# COMMITTEE OF ADJUSTMENT

## MINOR VARIANCE REPORT

APPLICATION: CAV A/019/2024-Deferred from Feb. 07, 2024

### **CAV A/019/2024 – 491 Fourth Line (West District) (OP Designation: Low Density Residential)**

Figure 2: 491 Fourth Line Site Plan (2<sup>nd</sup> Submission)

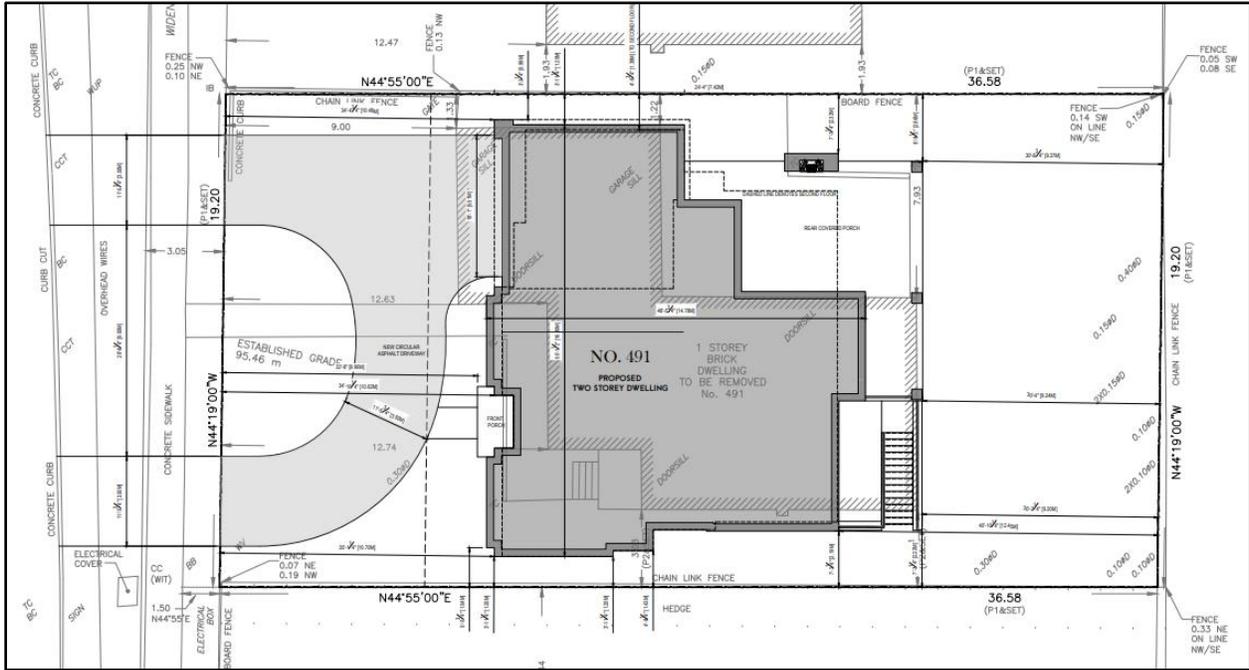
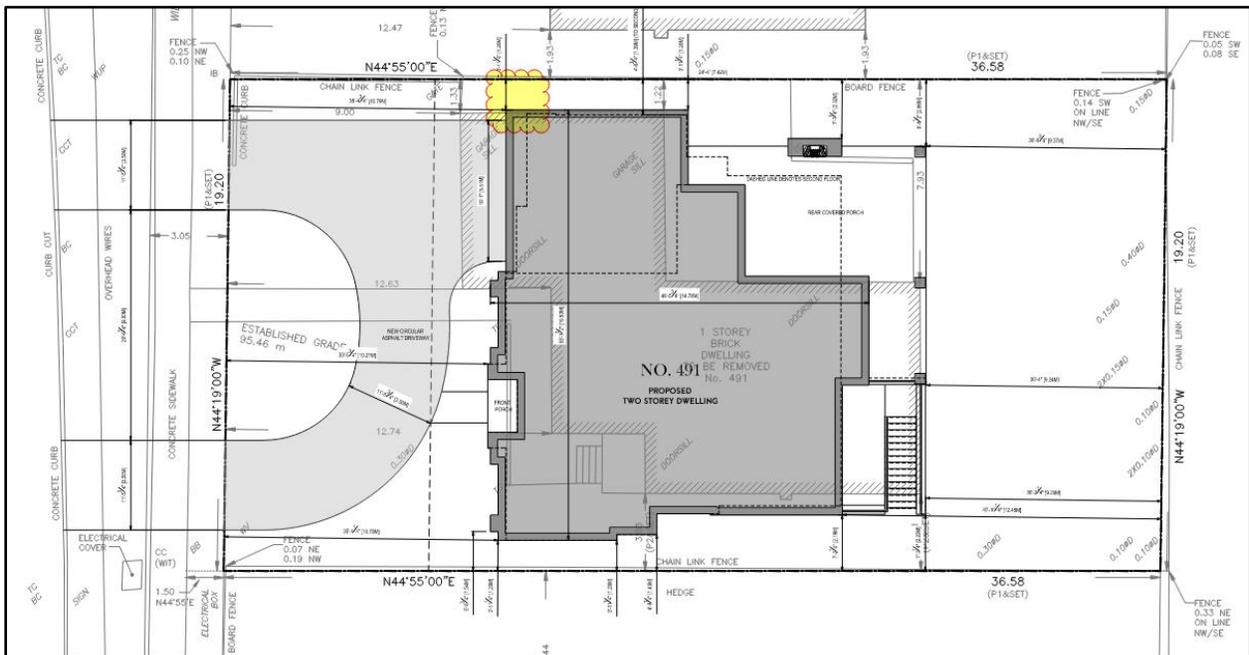
As seen in the renderings below, the applicant has revised the proposal to remove the architectural element on the left side of the garage that reduced the interior side yard setback. However, the applicant did not incorporate effective mitigative measures into the architectural design of the proposed dwelling, as previously advised in accordance with the [Urban Design Guidelines for Stable Residential Communities](#), to ensure there will be no negative impacts on the public realm, streetscape and that the dwelling would not appear larger than dwellings in the surrounding area.

Figure 8: Garage roofline (2<sup>nd</sup> Submission)

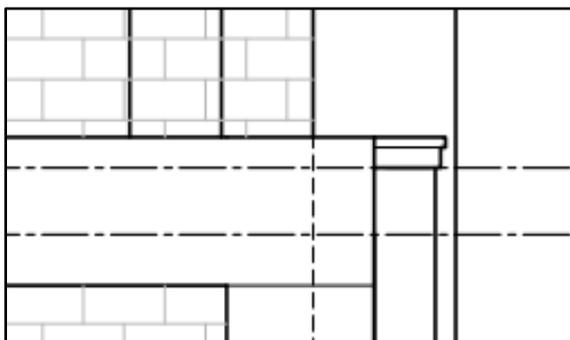
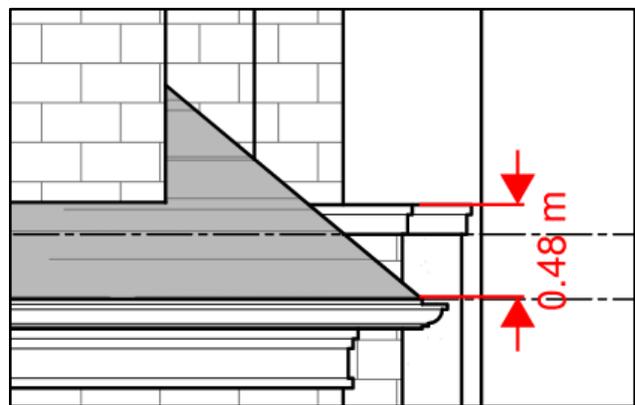
The applicant has incorporated a traditional pitched roofline over the attached garage which has reduced the height by approximately 0.48 m (1.57 feet). The applicant has also removed the architectural element on the side of the attached garage which previously created an interior side yard setback reduction.

Figure 10: 491 Fourth Line rear façade (2<sup>nd</sup> Submission)

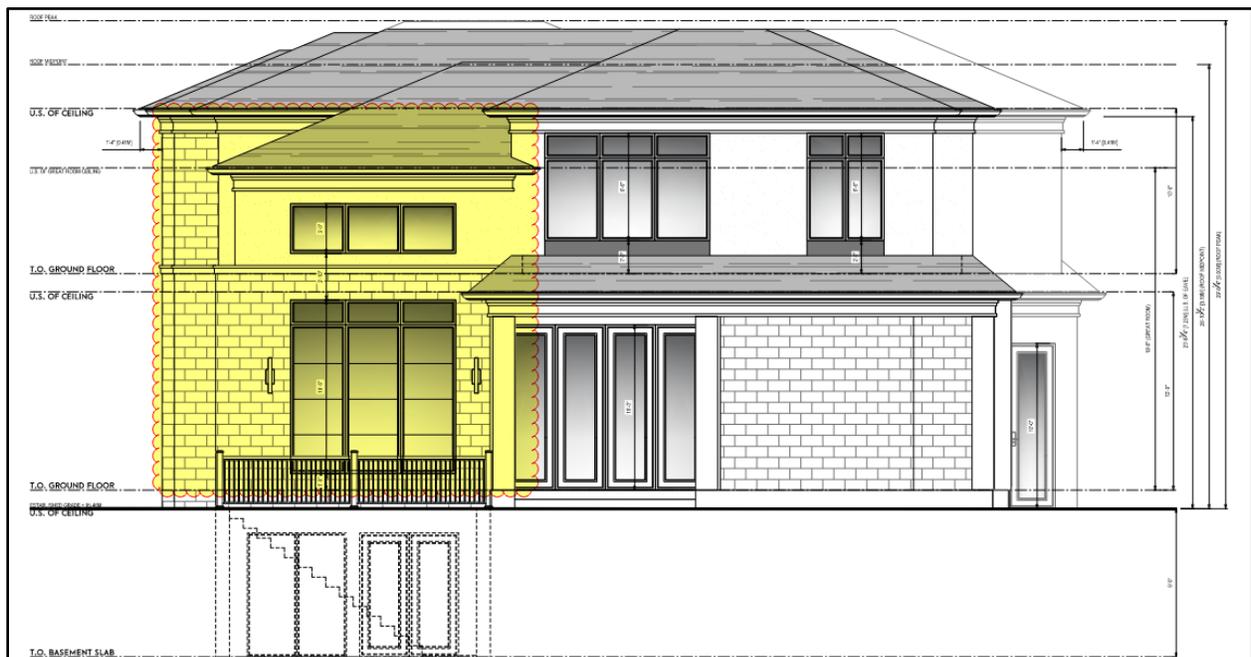
The rear elevations below demonstrate the modifications and revisions made to the rear façade, including a modification to the roofline where the large open to below is located and a modification to the area above the rear covered patio.

The applicant is proposing a modification to the rear façade of the proposed two-storey detached dwelling, which includes lowering the rear yard roofline above the rear open to below area by approximately 1.1 m (3.6 feet) to mitigate the massing and scale impacts and provide a transition to the neighbouring one-storey dwellings.
